UNITED STATES PATENT AND TRADEMARK OFFICE

09/808,253

Ikuya Tagawa

Office Action Summary

FIG. 1 5,800,935

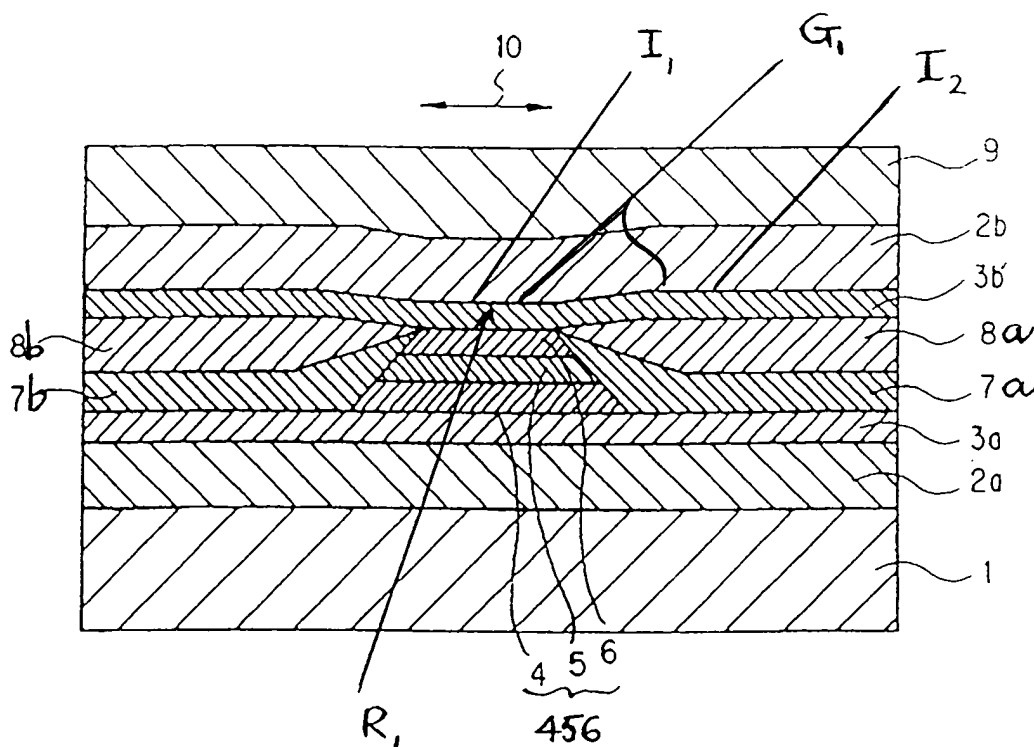
Ishi discloses, as in FIG. 1, a magnetoresistive transducer including a MR film 456 (see FIG. below) extending over a surface of a fundamental layer 3a; a pair of domain control layers 7a, 7b extending over the surface of the fundamental layer 3a so as to interpose the MR film 456 along the fundamental layer 3a, and an upper shield layer 2b opposed to the MR film at a first interface I_1 ; the upper shield layer 2b opposed to the domain control layers 7a, 7b at a second interface I_2 ; a groove G_1 between the first and second interface on the upper shield layer so as to isolate the first and second interface.

A...Applicant asserts that "the Ishi reference does not disclose a groove that isolates the first and second interfaces from each other." In response, in so far as the "groove" has been structurally defined in the claim, the Examiner considers the rising of the lower side of the shield layer 2b to encompass a "groove".
